Re: GA Terminal / Revenue Producing Hangar
Platte Municipal Airport
Platte, South Dakota
AIP # 3-46-0066-011-2020
A-6822

ADDENDUM NUMBER 1

GA Terminal / Revenue Producing Hangar

Addendum 1
04-02-2020

1 ENLARGED PLAN - TERMINAL
Scale 1/4" = 1'-0"

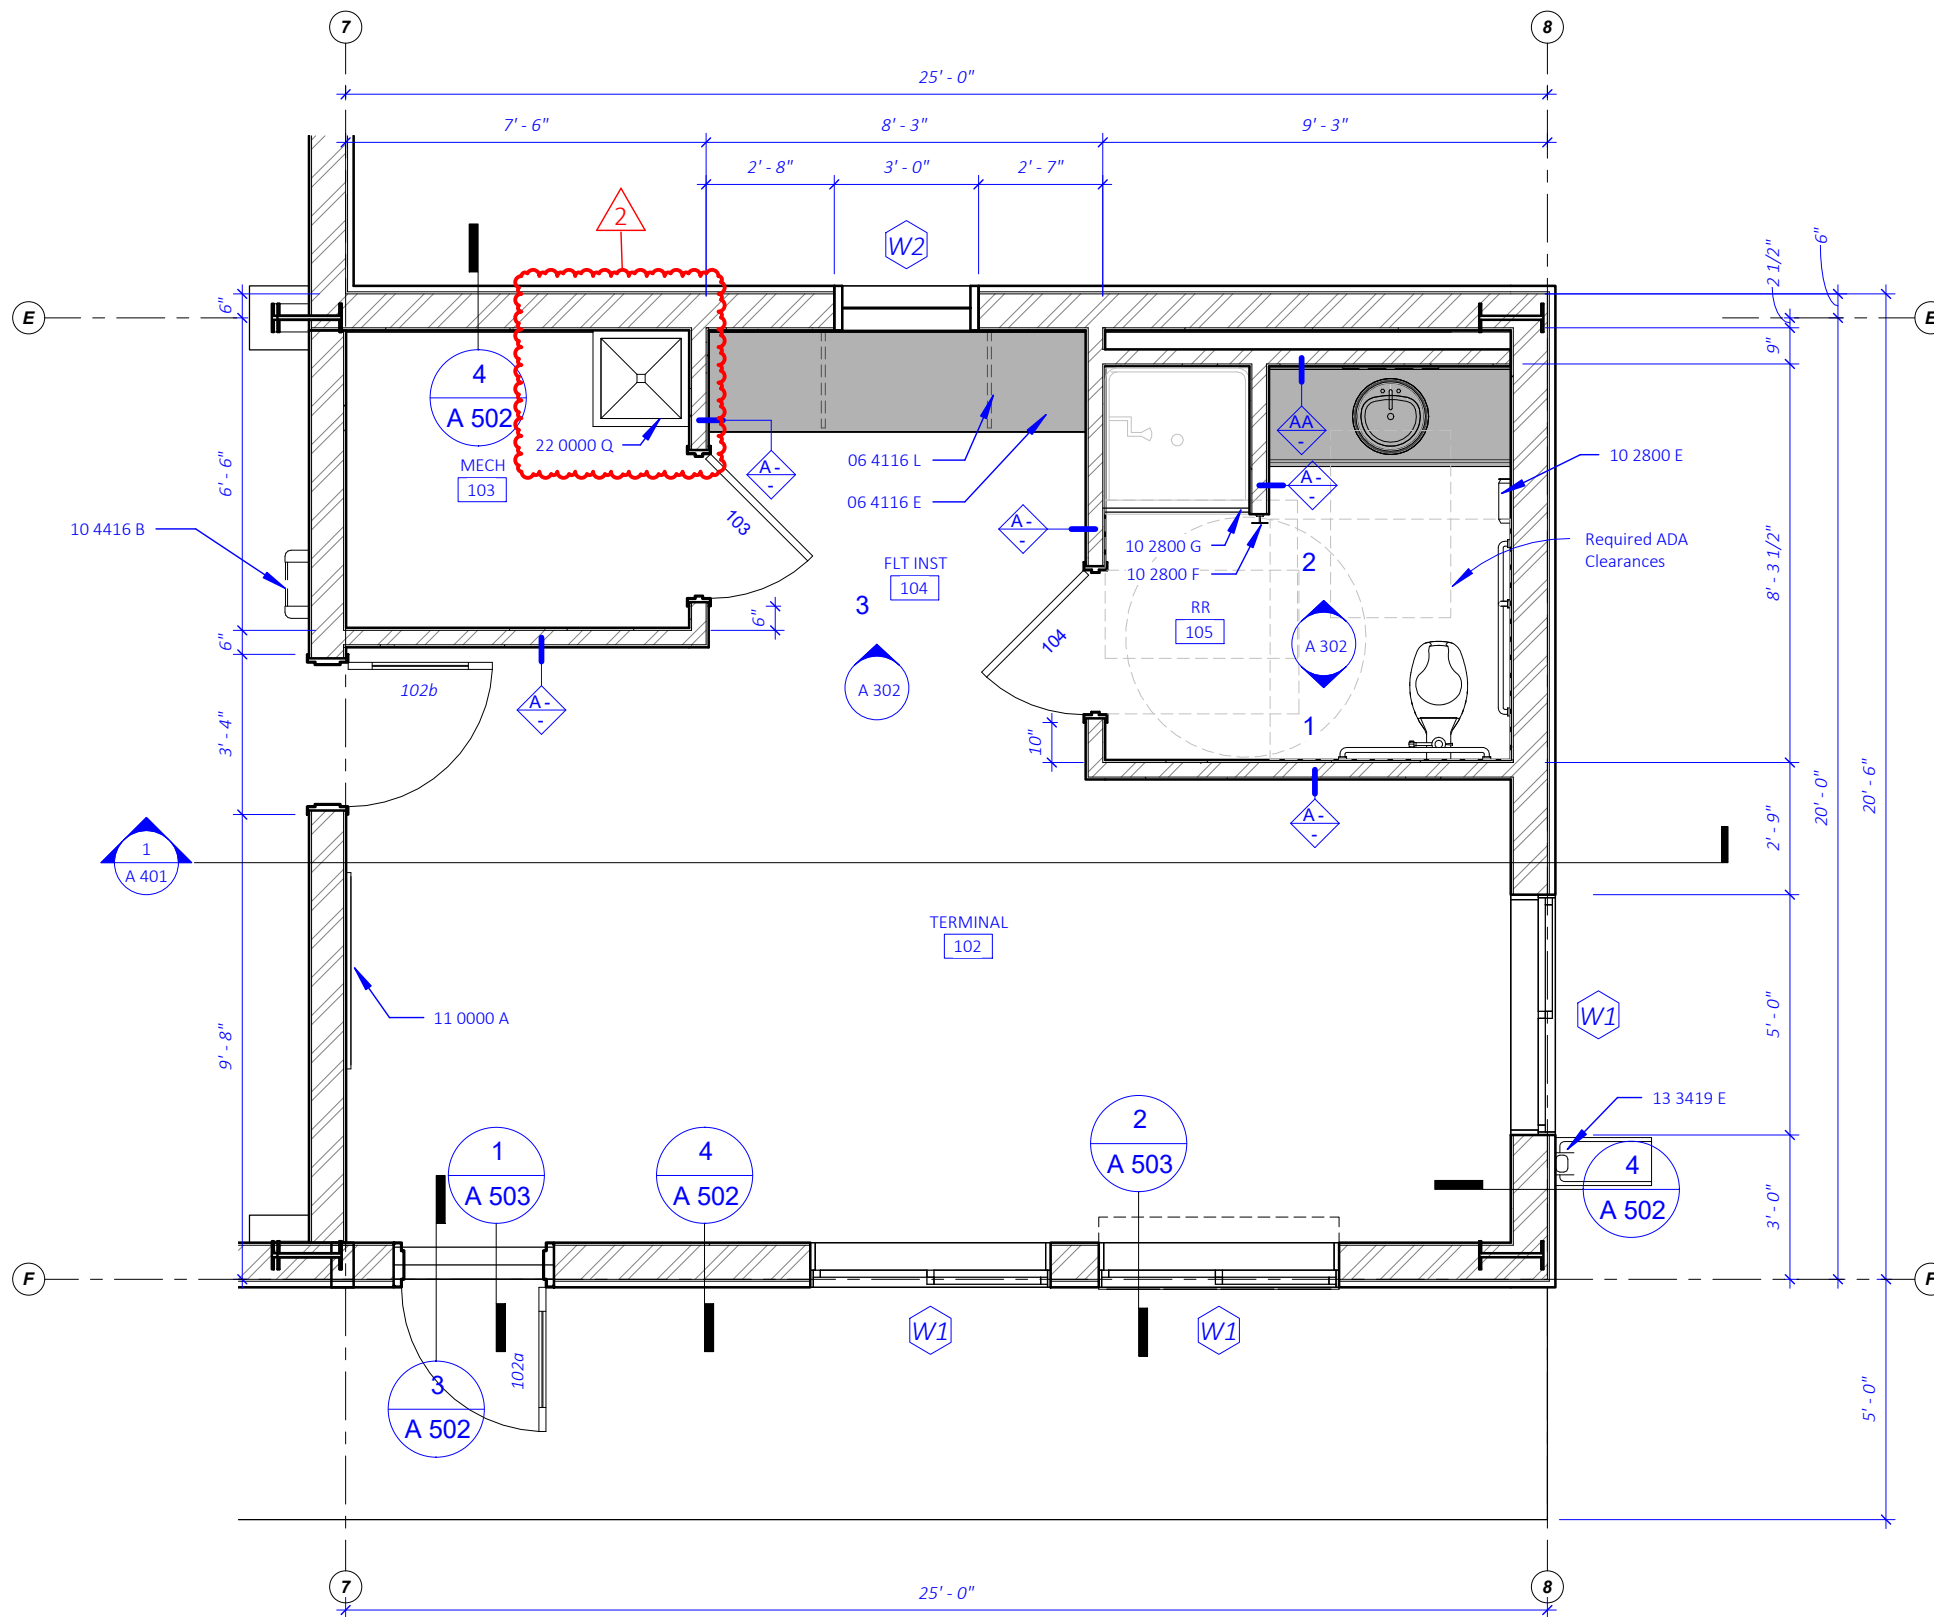
1. A mop sink and holder have been added to the plan. Provide FRP board on back and side walls 48 inches high by the width of the mop sink.
2. Provide adequate eave height to accommodate 18' high x 65' wide bi-fold doors. Clear opening height, with the bi-fold door in its retracted position, to be no less than 18'-0".

- 06 4116 E COUNTERTOP, PLAM
- 06 4116 L COUNTERTOP SUPPORT BRACKET
- 10 2800 E PAPER TOWEL DISPENSER, SURFACE MOUNTED, PROVIDED AND INSTALLED BY OWNER
- 10 2800 F ROBE HOOK
- 10 2800 G SHOWER CURTAIN AND ROD
- 10 4416 B FIRE EXTINGUISHER CABINET, SEMI-RECESSED
- 11 0000 A TV, BY OWNER
- 13 3419 E DOWNSPOUT, OPEN-FACED, PREFIN METAL WITH PREFIN INTERIOR TO MATCH METAL BLDG WALL PANEL. CONTRACTOR TO DETERMINE NECESSARY QUANTITY AND SPACING, BY METAL BUILDING CONTRACTOR
- 22 0000 Q MOP SINK AND HOLDER W/ F.R.P. BOARD ON BACK AND SIDE WALLS, 48"H x WIDTH OF SINK, See Mech. Mount WH-1 above on shelf.
